SUBJECT: Forwards addl info required for NRC to complete review of
 partial penetration weld substitution for sacrificial shield
 wall. Includes documents re shielding correction for shim
 gaps at elevation 541 inches to 5 ft & detailed drawings.

Subject: WPPSS NUCLEAR PROJECT NO. 2
NRR APPROVAL OF WNP-2
SACRIFICIAL SHIELD WALL
WELD PREPARATION

SUBJECT: W.O. 2808
WPPSS Nuclear Project #2
SSW Shielding Evaluation Status Report

SUBJECT SSW Shim Gap Repair

Figure 4-1

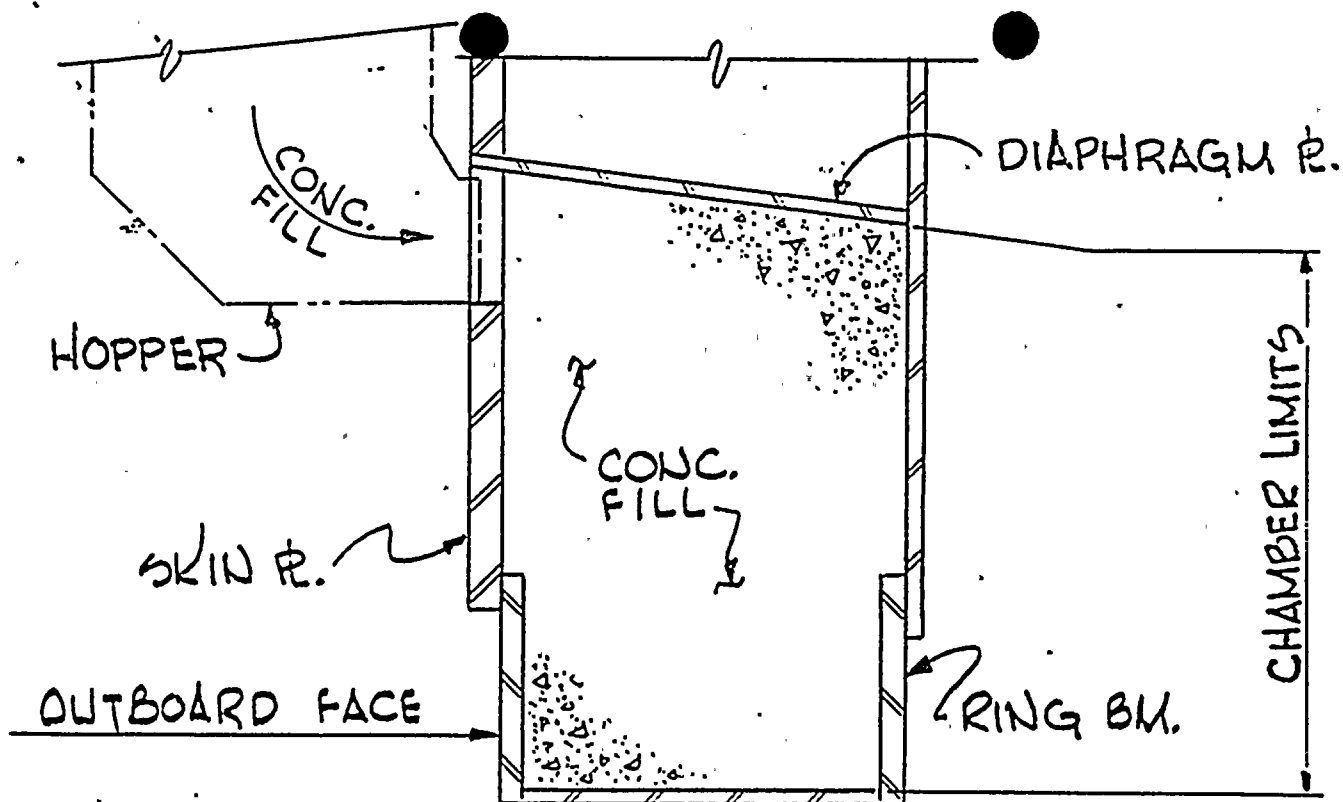
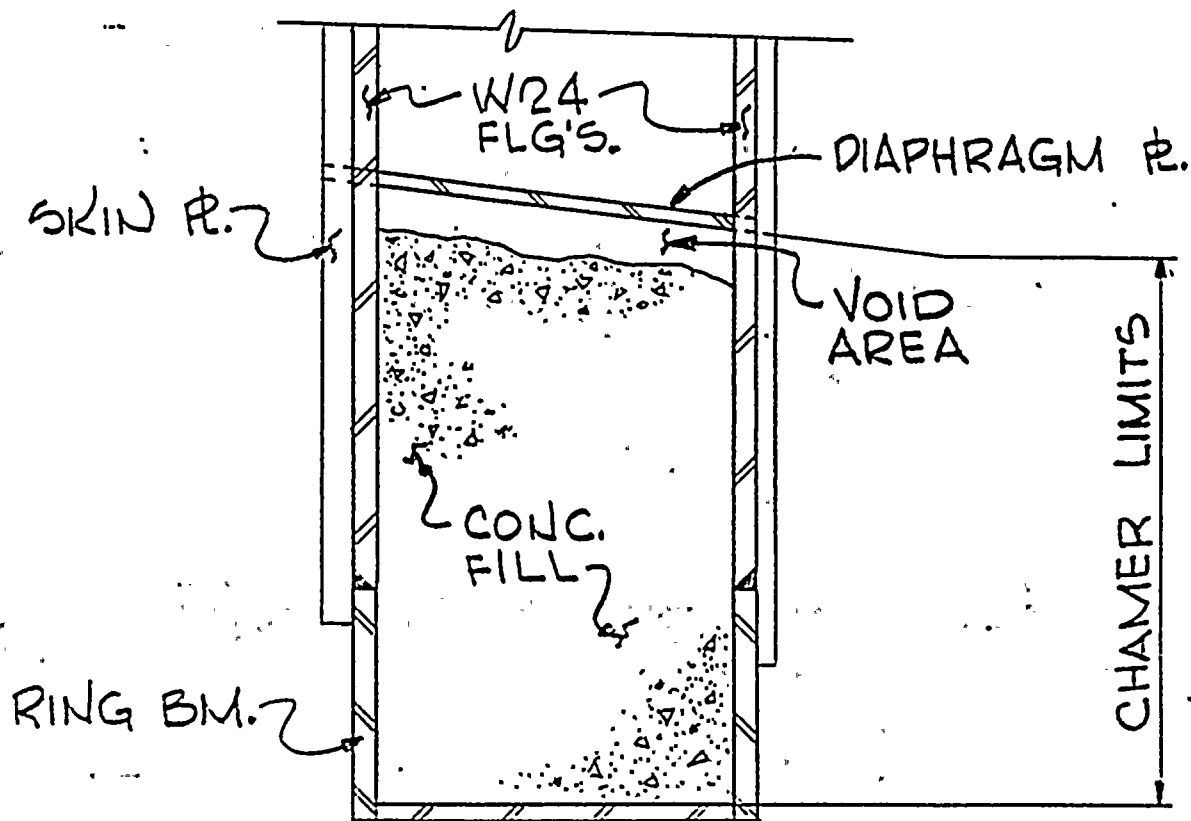
1. "Suspect" void location is based on compartment geometry and concrete fill procedure (see Figures 4, 5 and 6 for illustration of the three Categories (I, II and III).

2. Skin plate removed at 541'-5" elevation (0° - 15°) resulted in the discovery of concrete voids in the upper corners of this compartment (Category I). Another void was discovered at elevation 567' and azimuth 315° which is in a Category III type compartment.
3. Possible existence of concrete voids in SSW compartments based on numbers 1 and 2 above.
4. The active core region from 539' to 552' is of primary concern because of the flux reduction beyond this region.
5. Voids in the active core zone (539' - 552') represent radiation windows.

1. Determine if concrete void exists at suspect location by either drilling 3/4" Ø hole and boroscoping or by using the pulse echo method developed by Portland Cement Association.
2. Based on number one (1) above, voids shall be filled by either pumping the shield material through a 1/2" Ø fill hole with a minimum 1/4" Ø vent at the top of the void location or by flowing (by gravity) the shield material through a 3/4" Ø hole at the top of the void location.
3. 1/4", 1/2", or 3/4" Ø holes shall either be plug welded or threaded and capped closed.
4. Above methodology shall be developed and verified through prototype testing.
5. Shield material shall be BISCO NS1 (high density) or Owner approved equivalent.

Figure 6-1

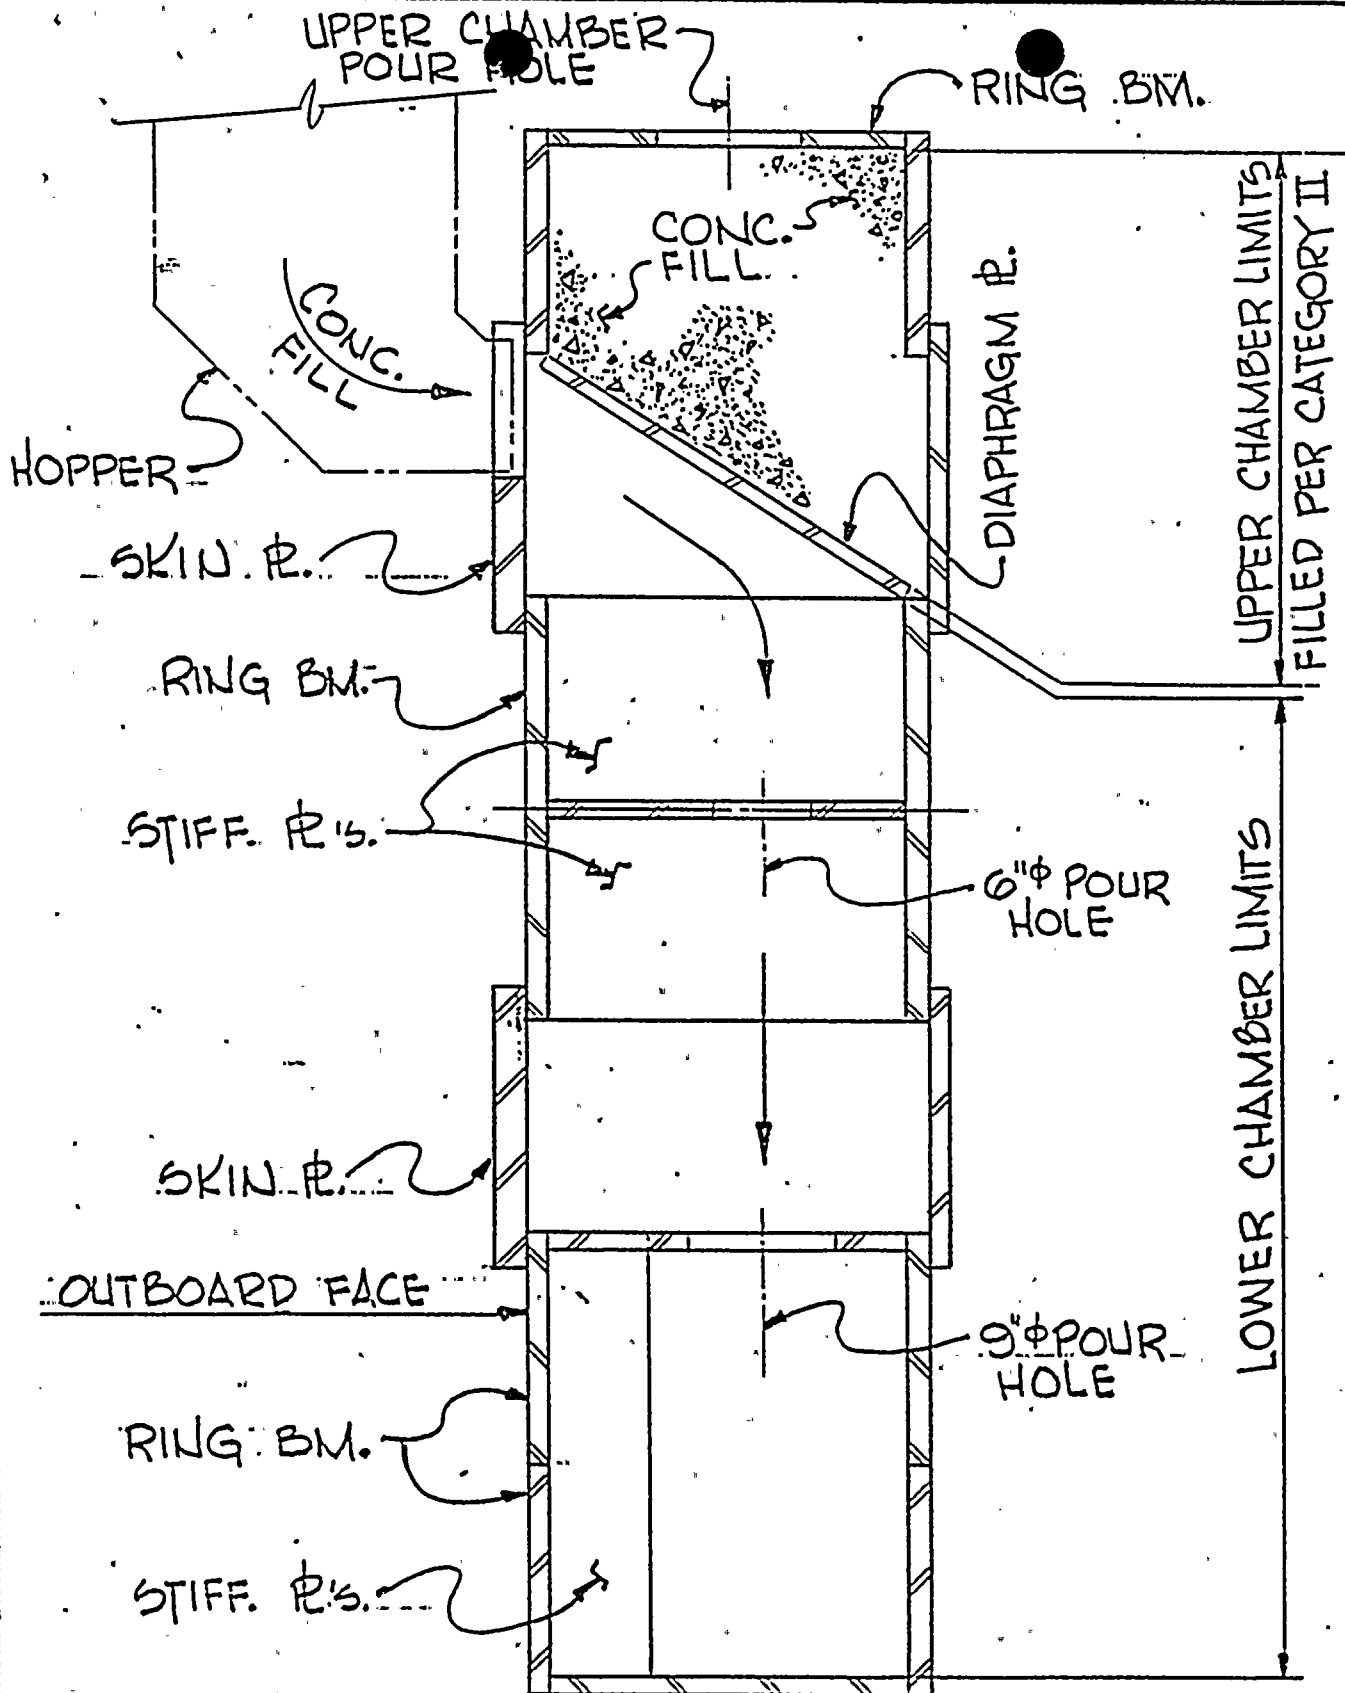
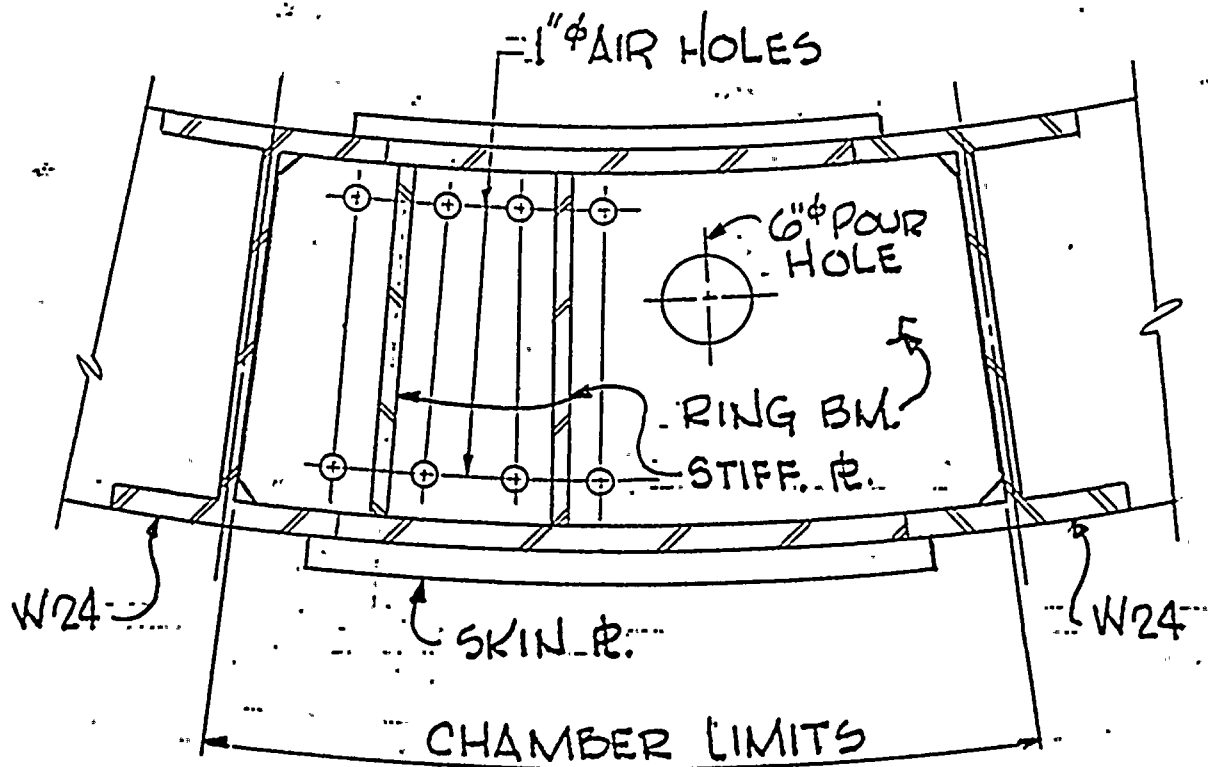
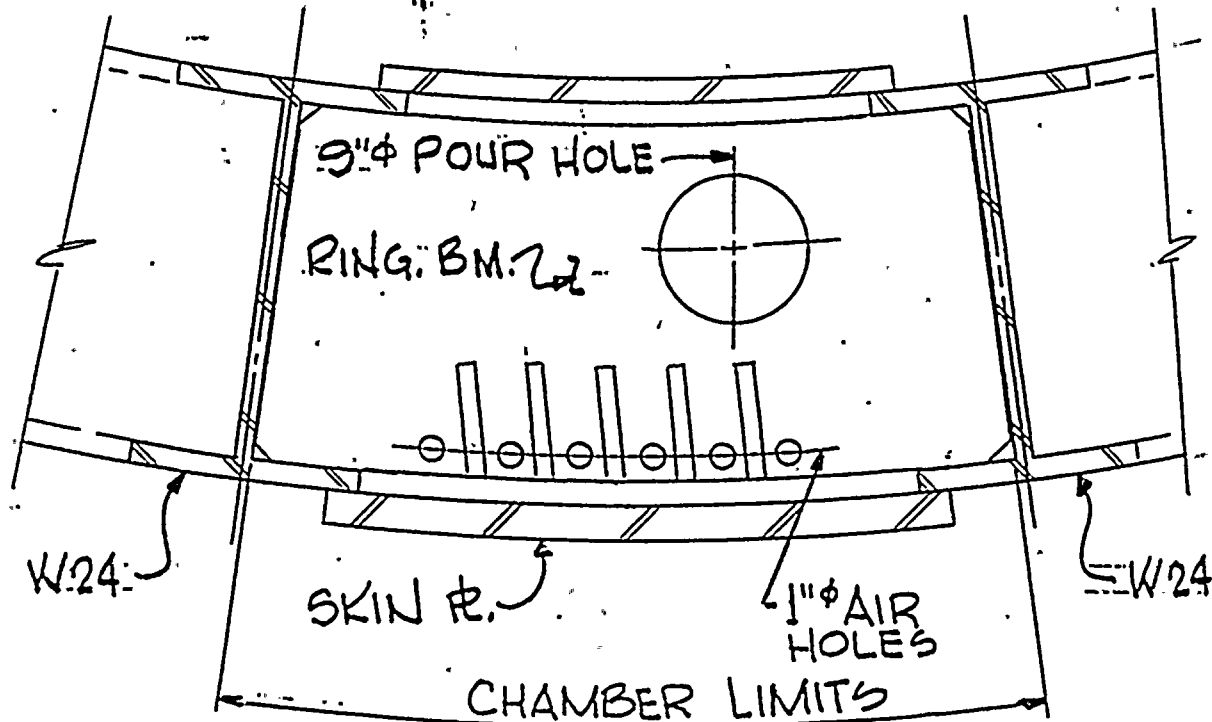
VOIDS SUSPECTED THROUGHOUT LOWER CHAMBER

PROTOTYPE TEST FIXTURE
(PLATES TO BE HELD TOGETHER BY "C" TYPE CLAMPS)
FIGURE I (NOT TO SCALE)

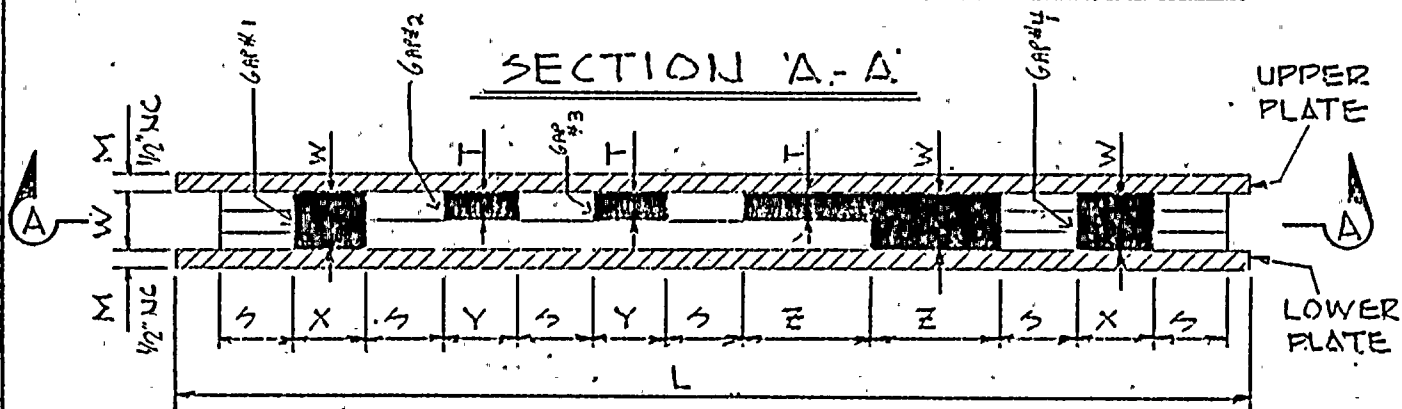
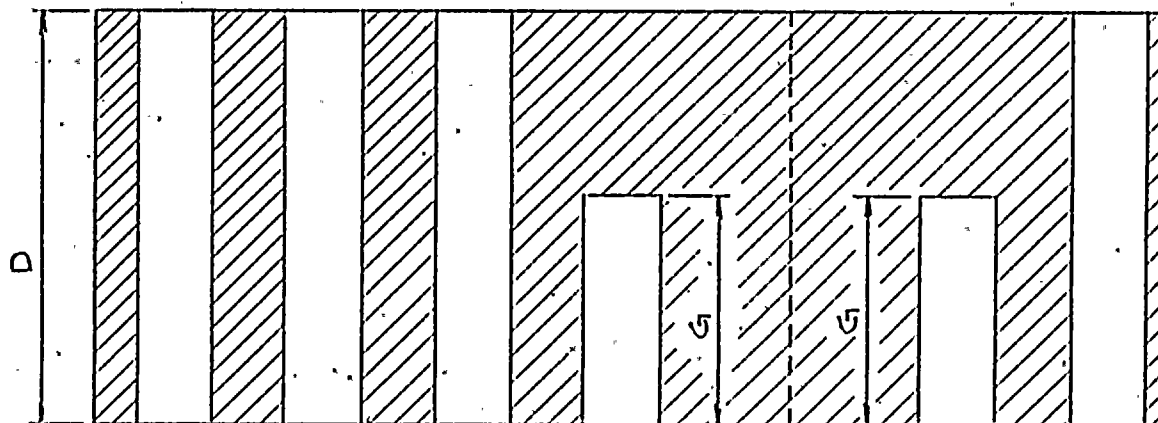
(b) Refer to figure 1 on sheet 3 of 3 of this PED. This figure delineates the test fixture required to perform prototype testing as called out in Sheet 2 of 3 of this PED.

- A. The Owner shall provide two identical test fixtures for PED 215-M-3320 prototype testing of the construction features of the shielding material. Each test fixture shall be capable of simulating four (4) owner prescribed gaps. The test fixture shall consist of two (2) plates for which varying shim stock may be inserted between the plates to simulate gaps between the shims at the 541'5" elevation of the SSW. The plates are held together by heavy duty "C" type clamps. The test fixture and all dimensions are delineated in figure 1 on sheet 3 of 3 of PED 215-M-3320. The gaps prescribed in this figure are indicative of those found per the survey. Each fixture (set of four gaps) shall fulfill the requirement for varying gap sizes as called out in step 3 on sheet 5 of 6.

DIM.	DESCRIP	DIM.	TOL.
D	SAC WALL RADIAL DEPTH	2'-0 3/4"	± 1"
G	SIMULATE TRANSVERSE FLOW	1'-0"	± 1"
L	LENGTH OF FIXTURE	3'-0"	NC
W	MAX. HEIGHT OF GAP	5/8"	± 1/32"
S	SHIM SEPARATION LENGTH	3"	NC
T	MIN. HEIGHT OF GAP	1/16"	+1/32" -0
X	MAX WIDTH OF GAP	2 1/2"	± 1/8"
Y	MIN. WIDTH OF GAP	1/16"	+1/32" -0
Z	NON-INTERFERING TRANSVERSE FLOW ZONE	3"	± 1"
